No.	EIR/FSS Section(s)	HRCA Issue/Comment	Category	Responsibility (HRCA/MMM)	Response
					soils which will not be conducive to mitigating infiltration. We do not agree that the potential exists for greater infiltration on the site that the water balance predicts. The water balance is based on clay-rich soils (predominantly Soil Type D (~80%), with some Soil Type D (~20%)). The water balance predictions of monthly base flows in the watercourses were identified in the report to be in close agreement with flows measured at the watercourses within the site. Additional investigative techniques such as percolation testing would be carried out during detailed design in the areas where infiltration measures, such as infiltration swales, are specifically proposed along the periphery of the natural environment areas. As noted in the report and in the response above, site grading activities (cut and fill) over much of the developable land area will leave large areas of the site with exposed soils that are not conducive to effective mitigative measures using infiltration.

37	Section 6.3.1.1	Meander Belt Width, Page 6-2 & Appendix 6.7 - Reach 14W-12A is not included within Table 1 within Appe

Figure 7: Water Temperature at Maximum Pond Depth: 2-3 m Depth
14W-14A

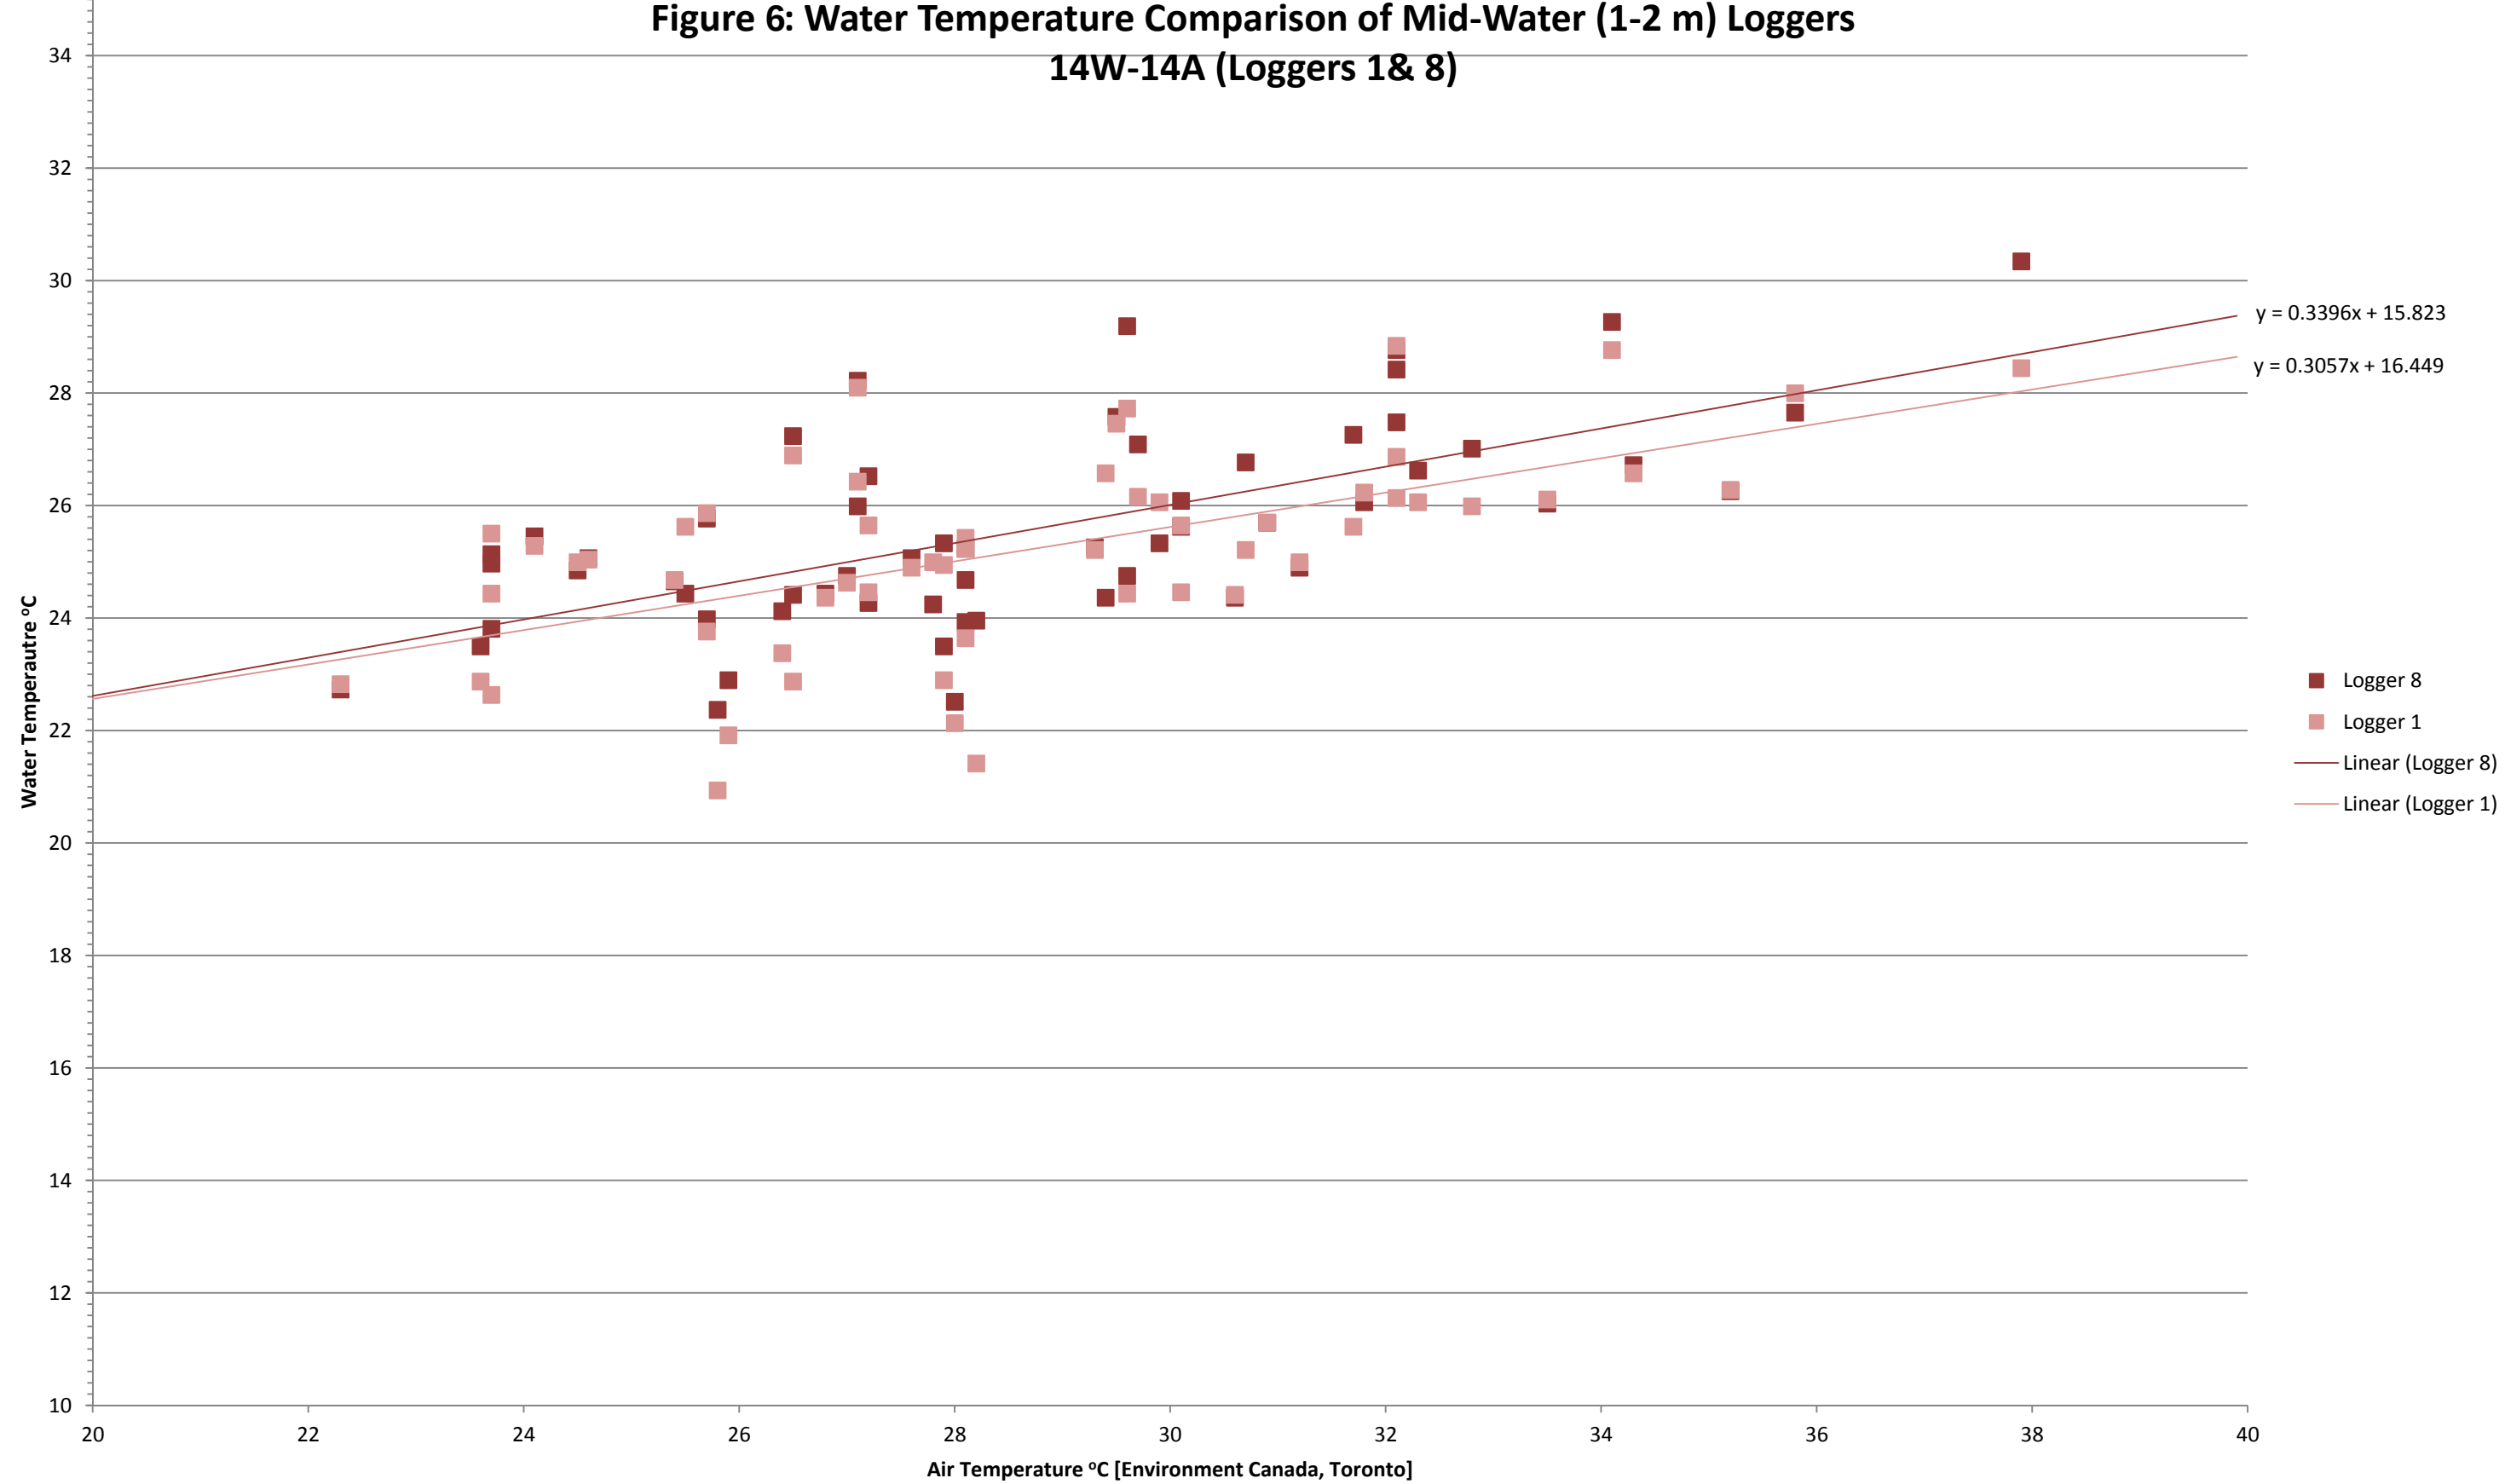
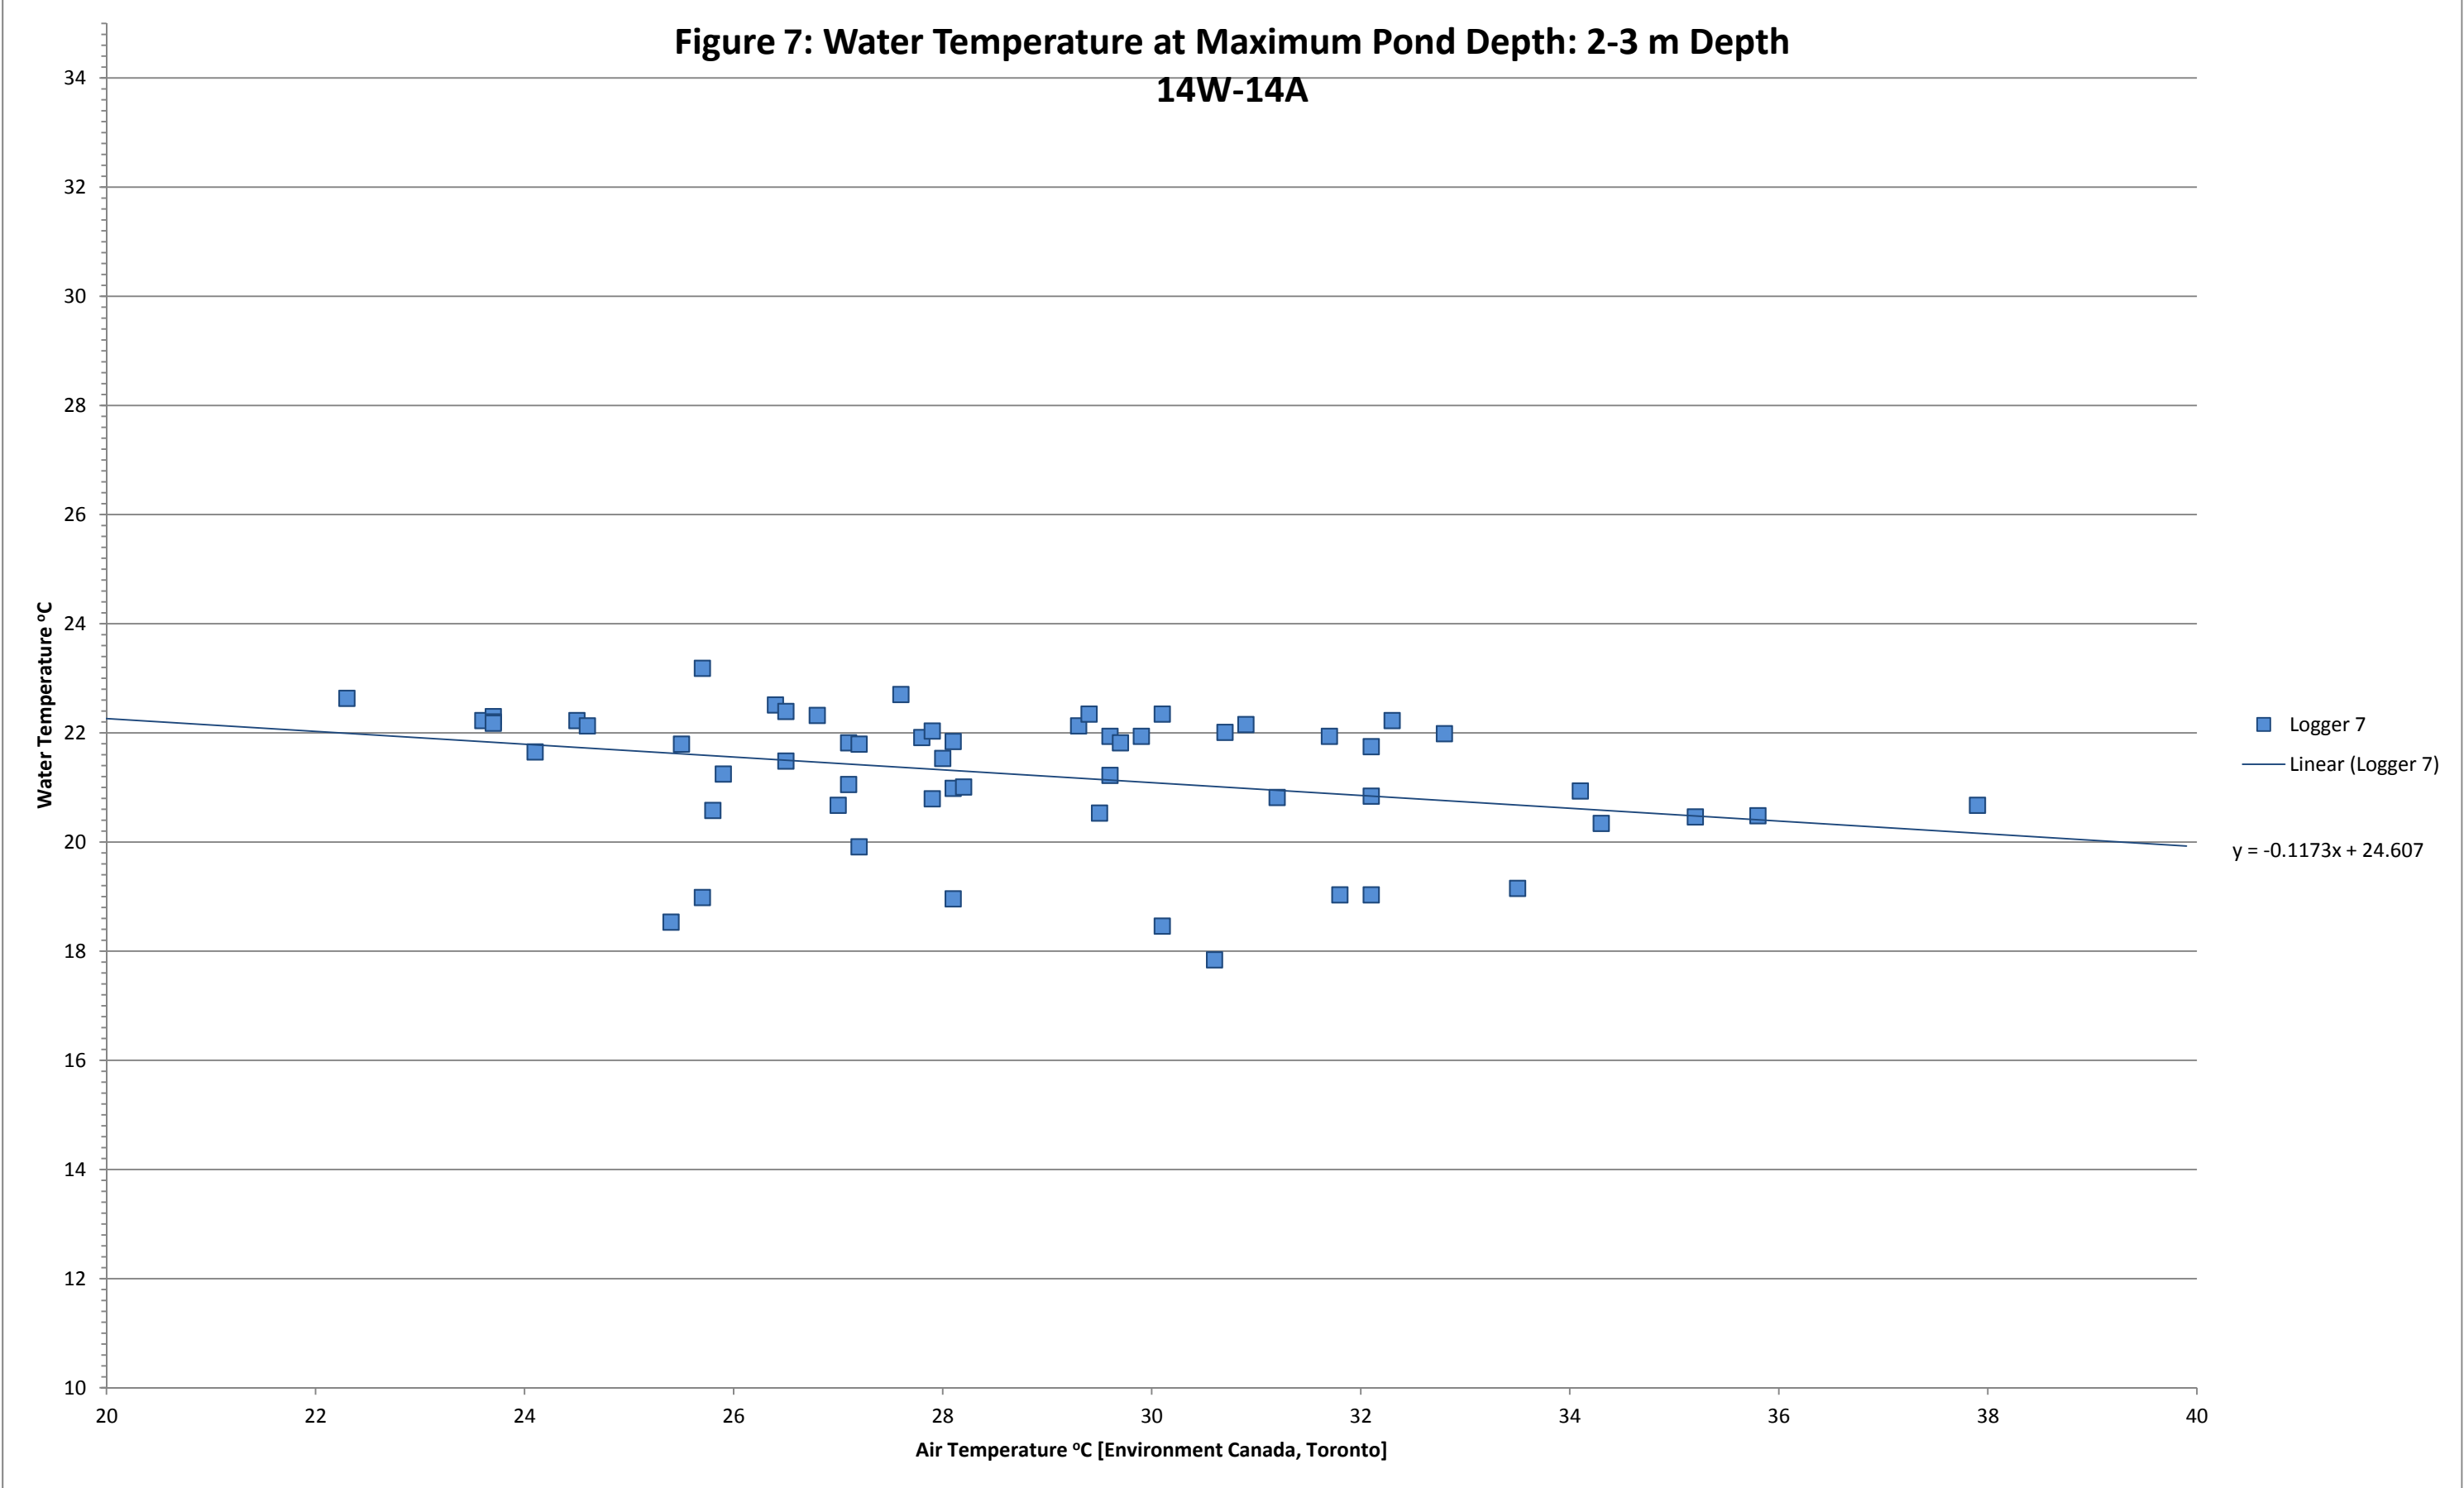
64	Appendix 5.6	Water Temperature Monitoring Data - Comment not addressed to the satisfaction of CH Staff because the STATE analysis was not applied to the temperature data graph.	2	MC	Following numerous attempts to unsuccessfully use the STATE analysis software that was requested by CH we contacted the developer of the software for direction. The developer stated that error/crashing experienced by MMM staff was due to the sample size being shorter than 6 months and they have yet to resolve this issue.

No.	EIR/FSS Section(s)	HRCA Issue/Comment	Category	Responsibility (HRCA/MMM)	Response
					As you are aware CH requested in their August 5, 2011 email that water temperature data collection in the farm pond with specific reference to water temperature data collection be initiated as soon as possible to include the month of August and extend to September 15th. This information was relayed by CH in advance of the email in a voicemail message from L. Smith in June and as a result the loggers were in place by June 30, 2011. Although the recording period collected data through the summer months and beyond, it was not sufficient to capture the required timeframe to allow the STATE analysis to work. Furthermore, an analysis of the water temperature was undertaken using 3 other acceptable methods. Water temperature data was initially assessed using the methods in the <i>Ontario Stream Assessment Protocol (OSAP) (Stanfield, 2005)</i> and <i>A Thermal Habitat Classification for Lower Michigan Rivers (Wehrly et al, 1999)</i>. The general results were presented to CH during a site meeting and CH requested the assessment of the data using the <i>Evaluation of a Simple Method to Classify the Thermal Characteristics of Streams Using a Nomogram of Daily maximum Air and Water Temperature (Cindy Chu, et. al., 2009)</i>. This third tool was also used to assess the water temperature data. All three methods yielded relatively consistent results and were presented in the EIR. Given the limitations of the STATE analysis tool, the
